BIDDING ADDENDUM NO. 1

**CATAWBA COUNTY CATTLEMEN'S ASSOCIATION
EDUCATION CENTER
NEWTON, NORTH CAROLINA
CBSA Project 2024.008
August 24, 2026**

MT OLIVE CHURCH ROAD
SITE PLAN - ELECTRICAL
SCALE: 1" = 30'-0"

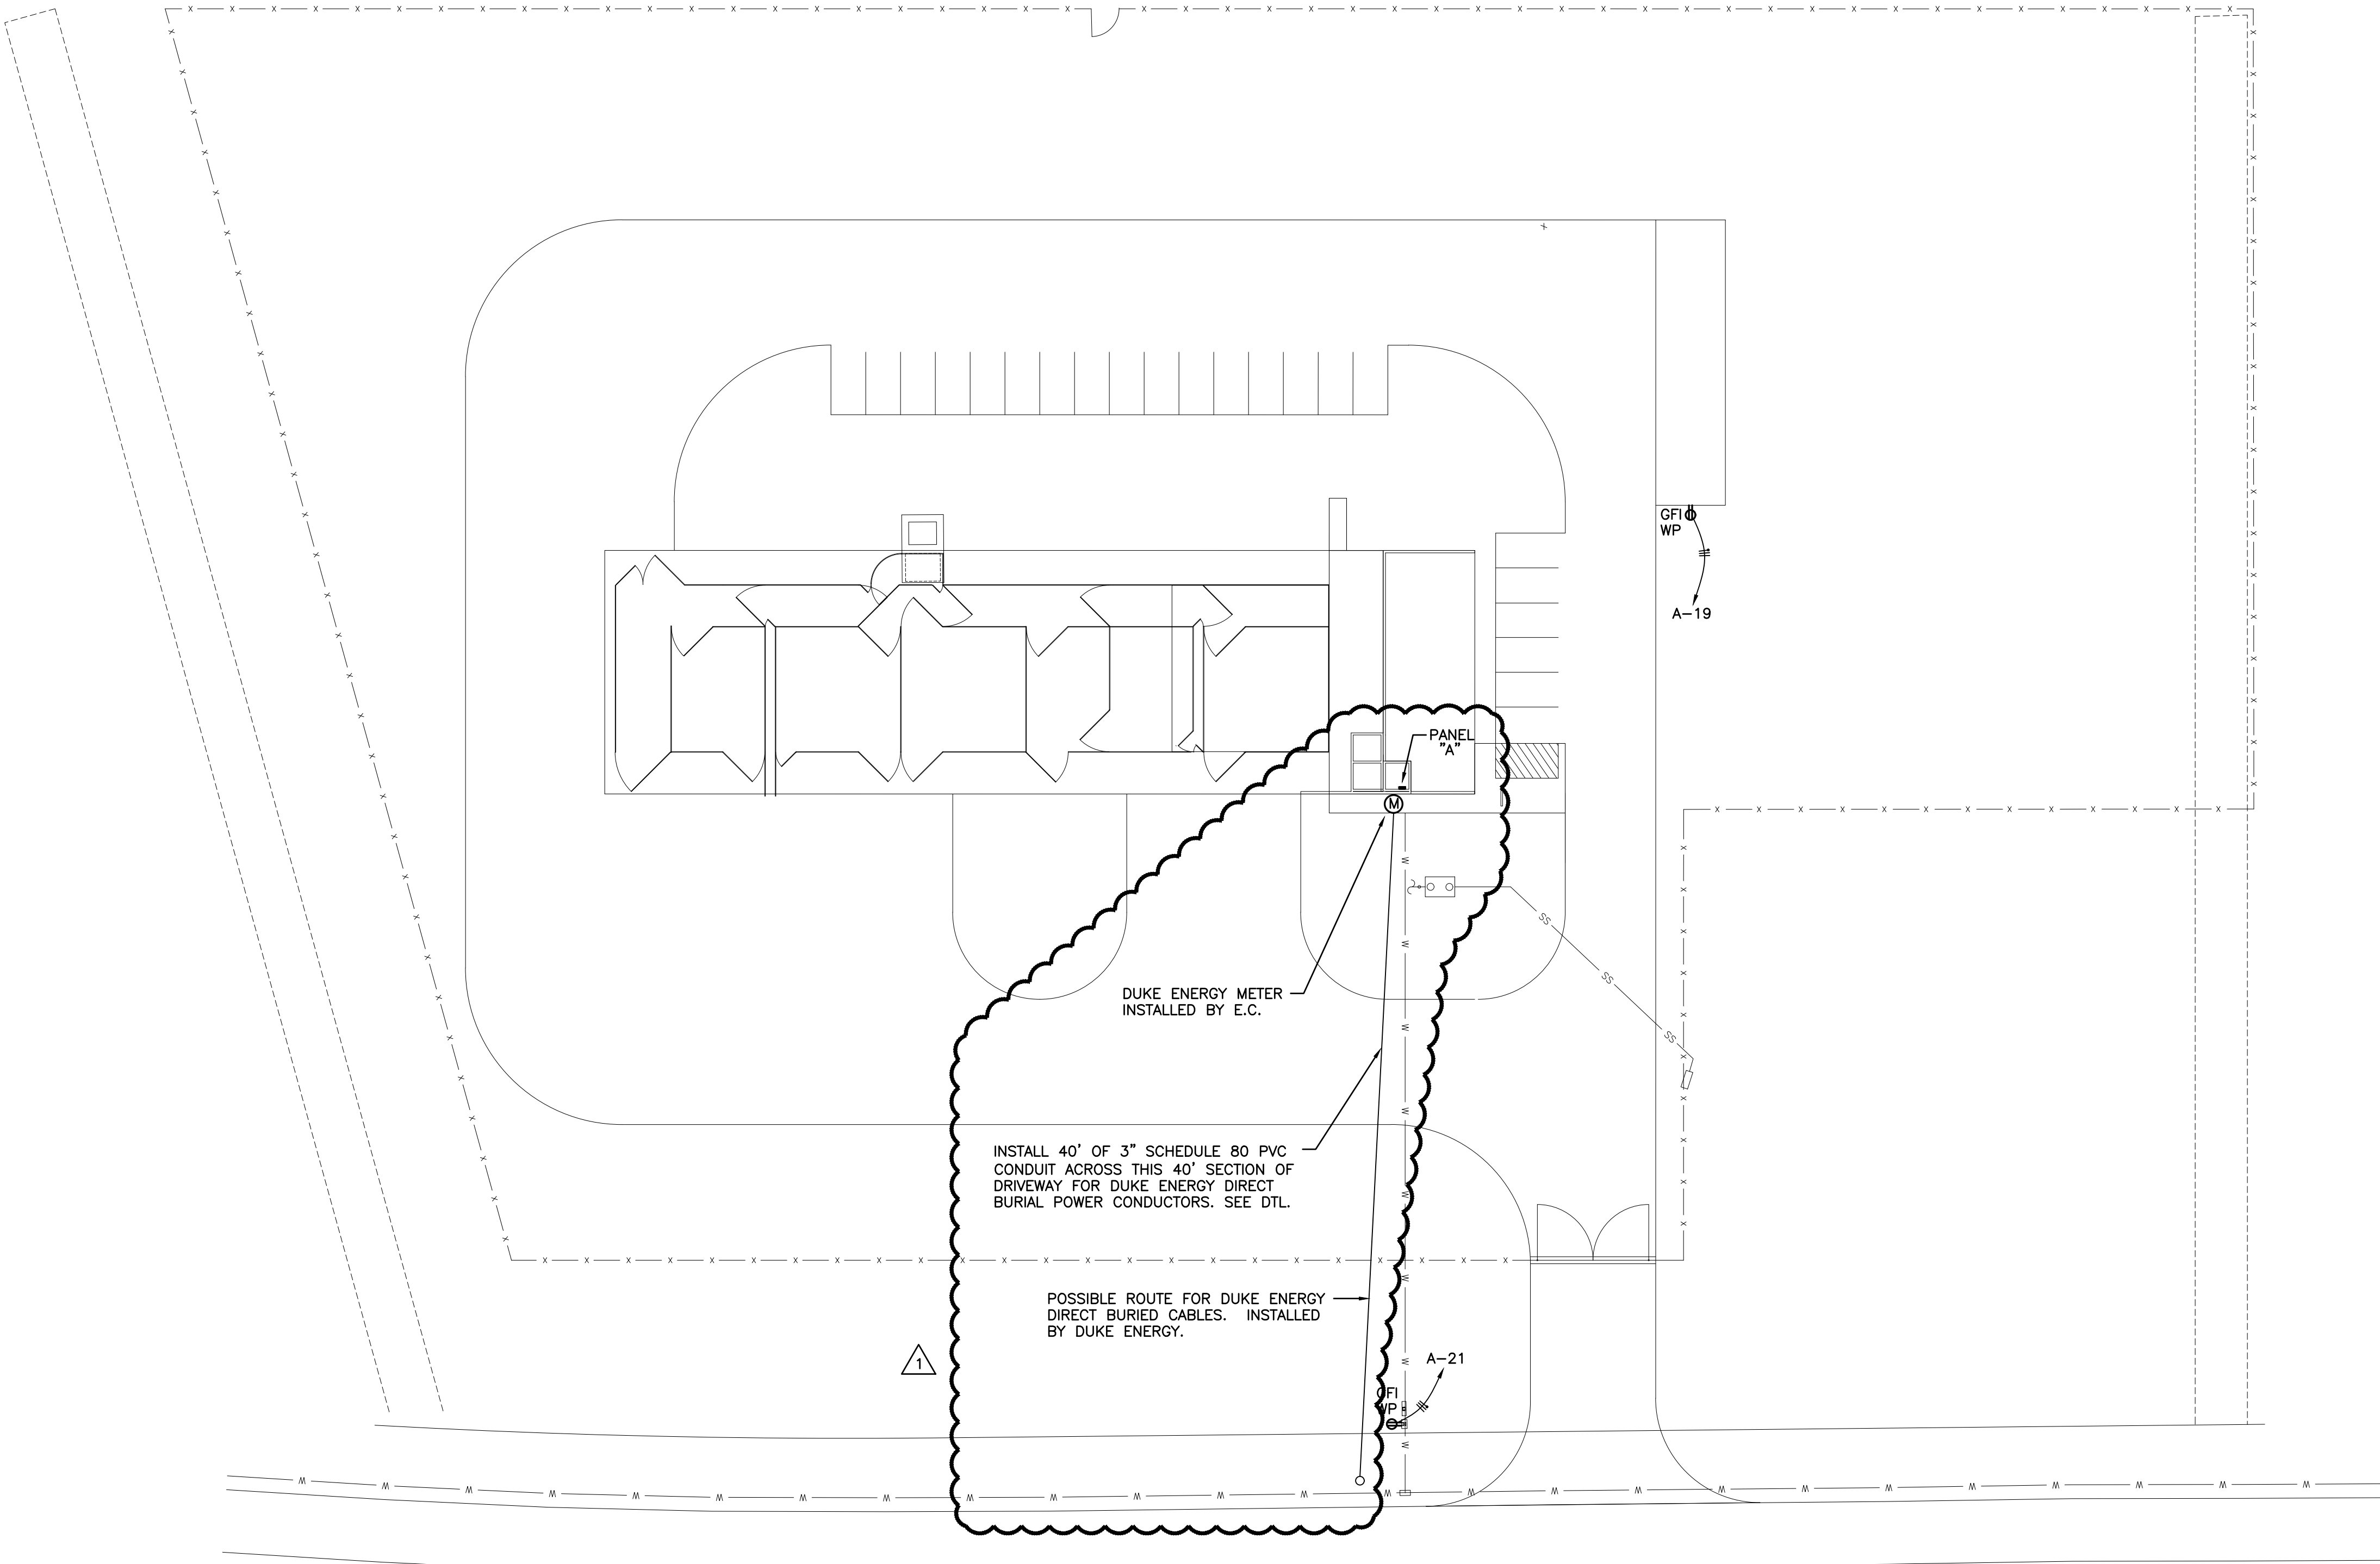
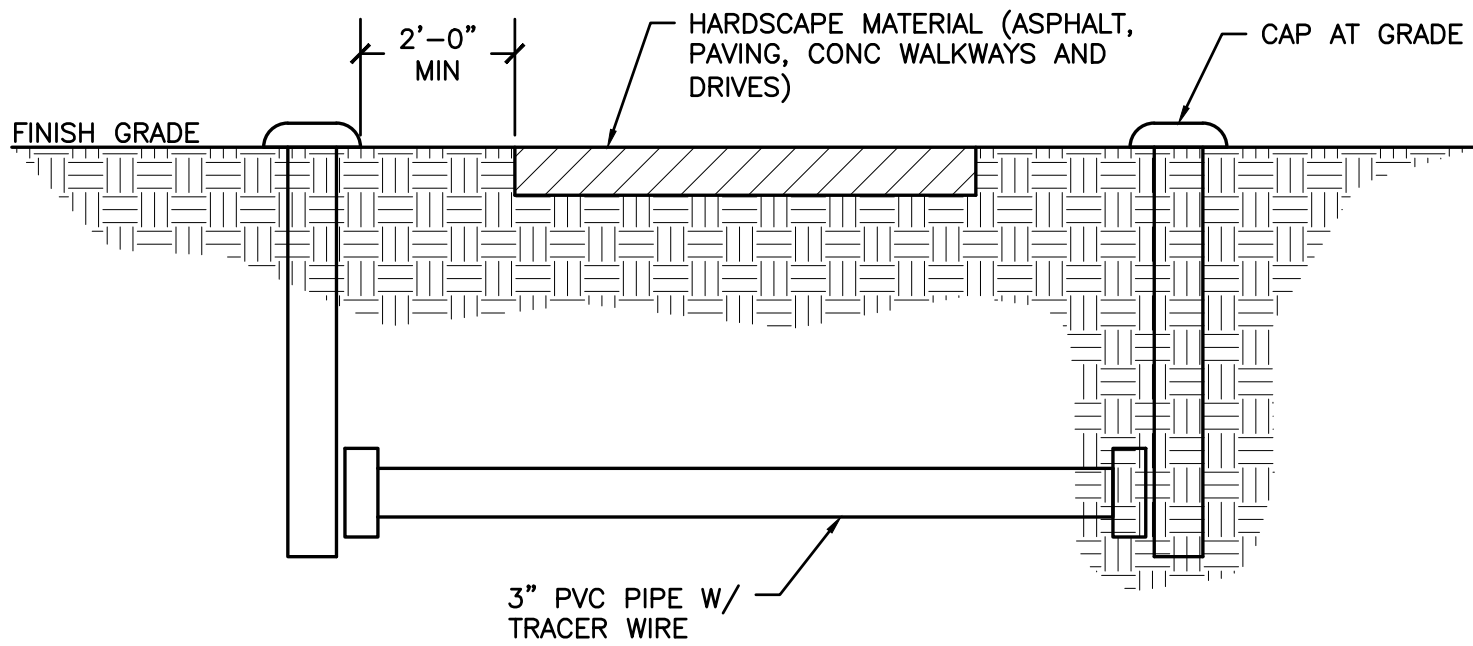
16. Possible route of direct buried power cables by power provider is indicated. Detail for Conduit is provided to be installed under paved drive and marked accordingly. See attached drawing.
